**University of Connecticut Health Center
CLAC Tower Renovation Project**

ADDENDUM #03

August 19, 2013

AD-100

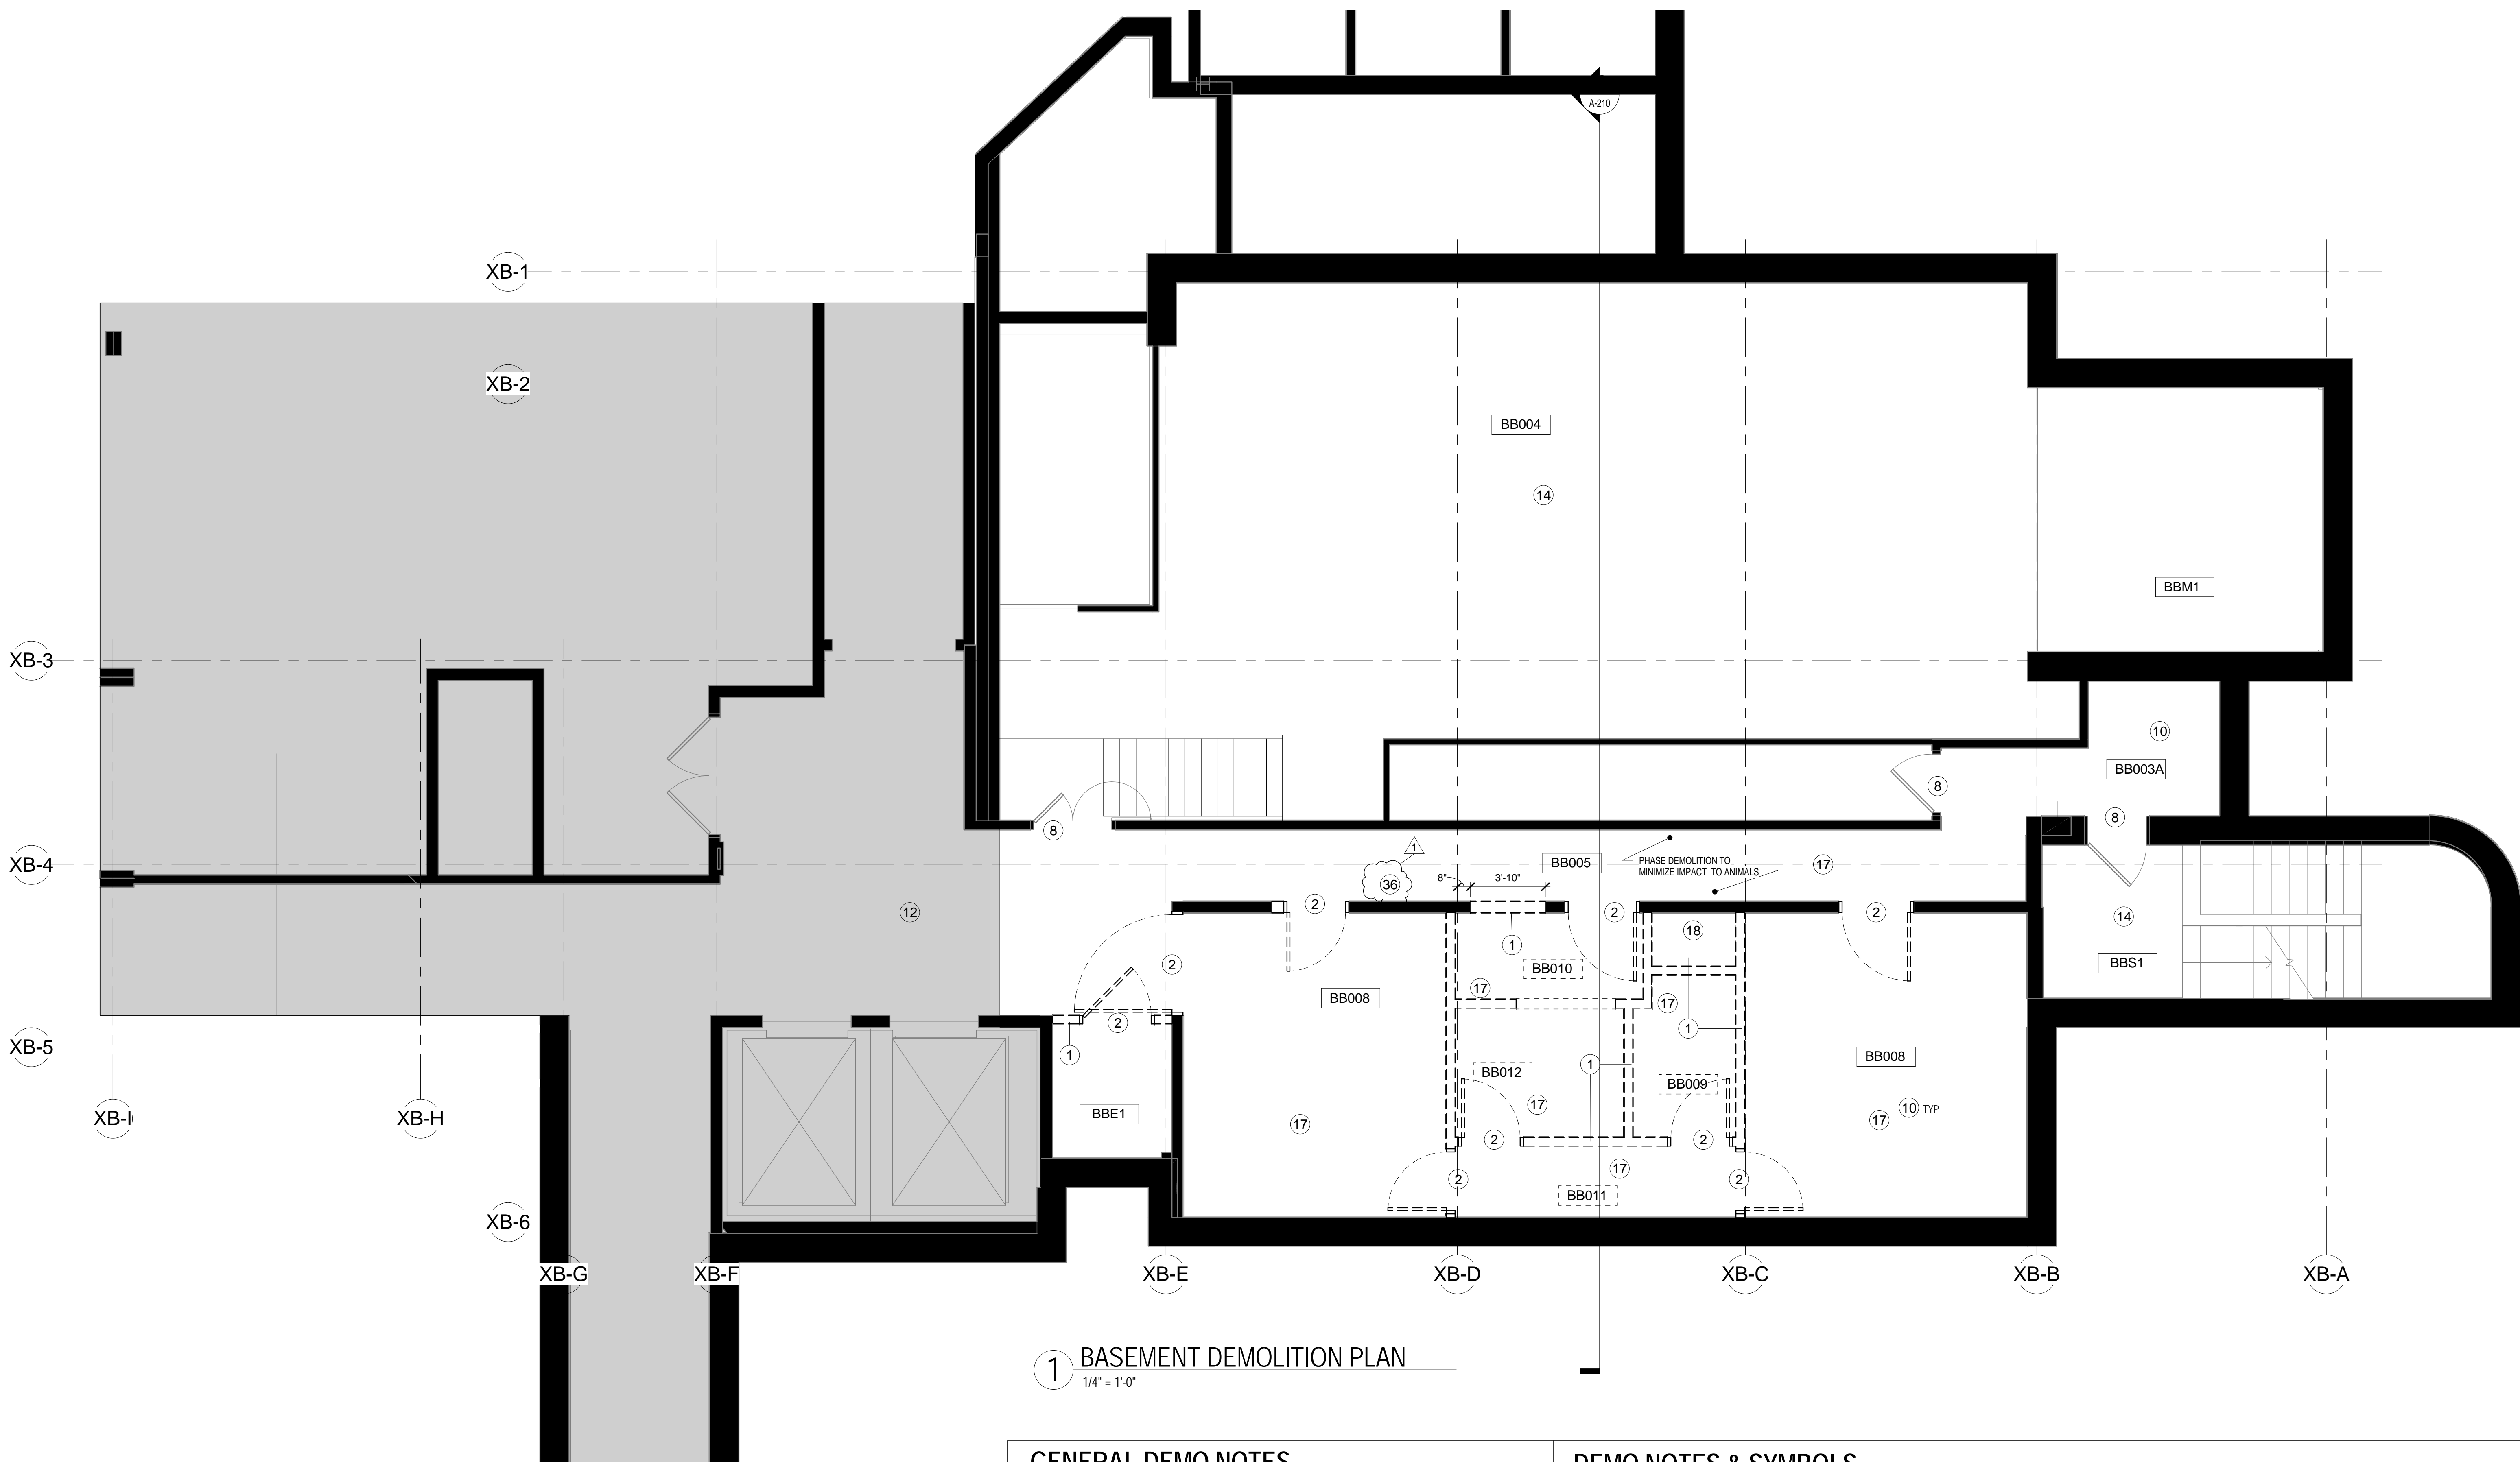
6. Remove all items from the building, including wall guards, ~~fire valve cabinets~~, partitions, flooring, ceilings (plaster, gypsum, acoustical), walls, casework, steel stairs/landing, shelving, ~~autoclaves~~, ~~wall clocks~~, ~~penthouse cage~~, etc. as defined by the contract documents. Basement ~~in-wall autoclaves~~ ~~is~~ **are** to be removed by this contractor.

HVAC DEMOLITION
BASEMENT FLOOR PLAN

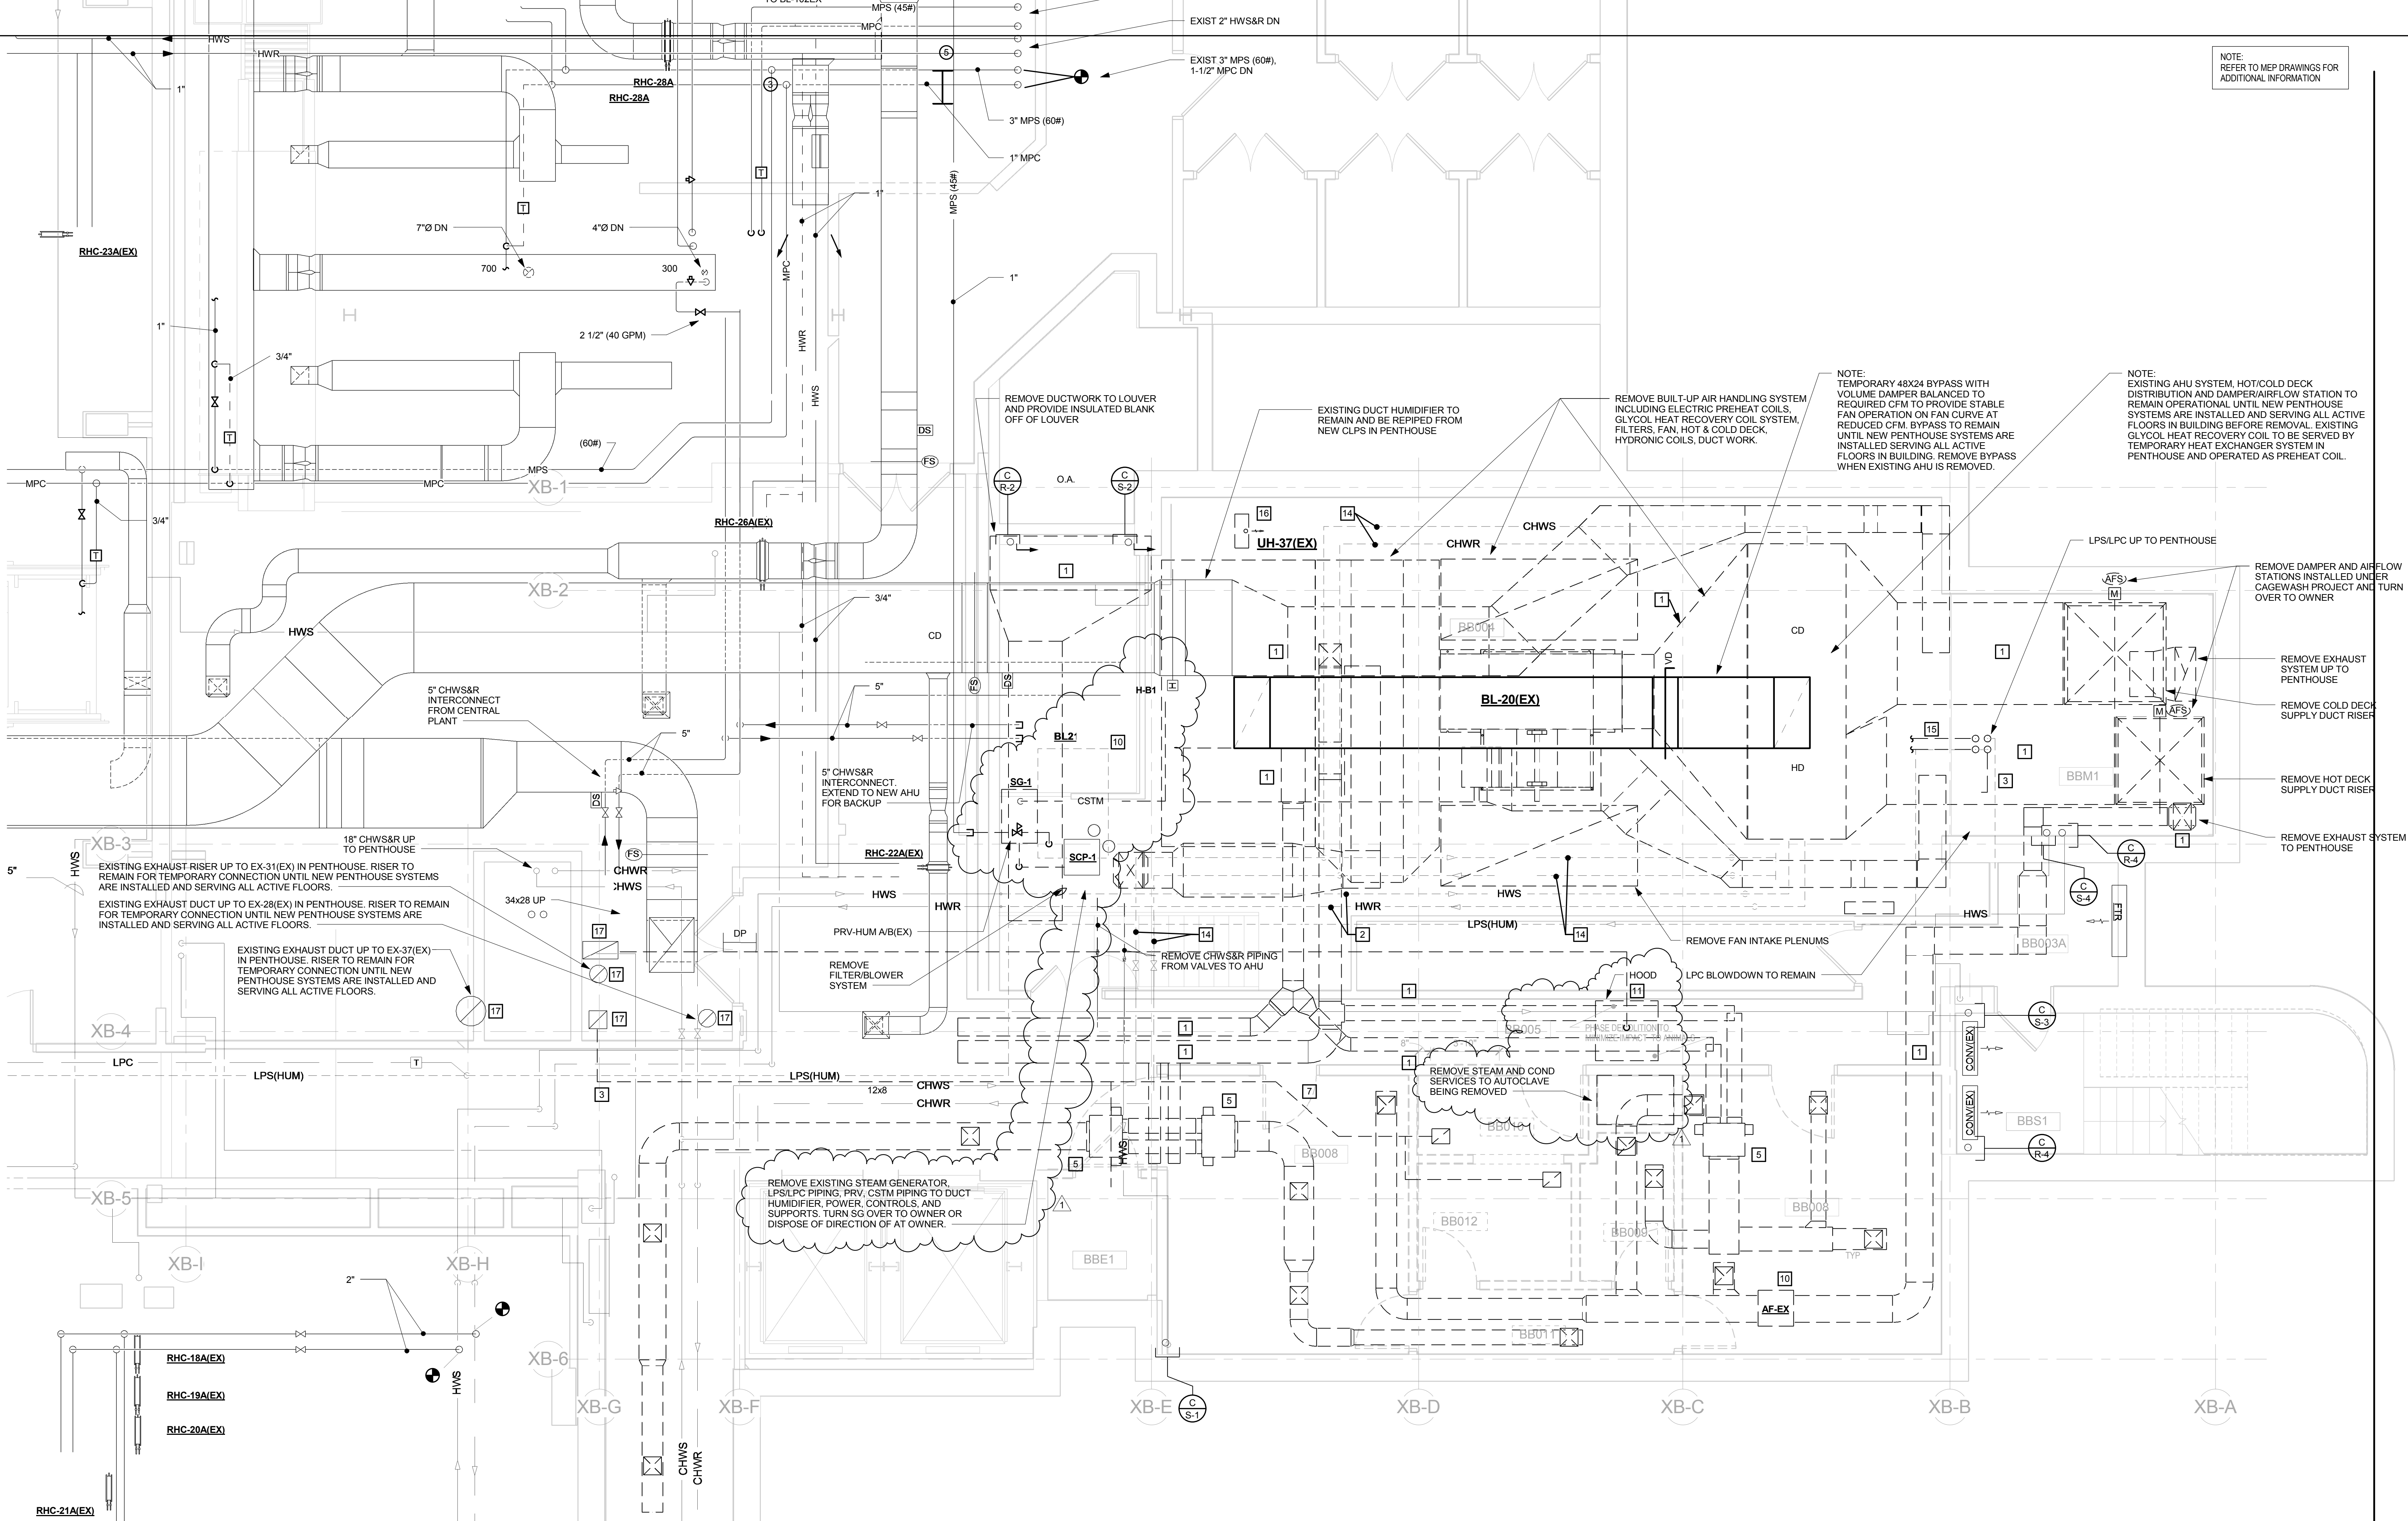
6. Demolition of all HVAC items per the intent of the drawings. Disconnect, cap and make safe all HVAC piping, pumps, coils, valves, heat exchangers, **steam generator**, etc. **with all associated supports and hangers. Include disconnection of all equipment scheduled for demolition by others, including AHUs, exhaust fans, autoclaves, etc.** All demolition materials are to be dropped to the floor and cut into small enough pieces to be efficiently removed by others via the elevator. All pieces must be piled in a neat, orderly and safe manner for removal by others.
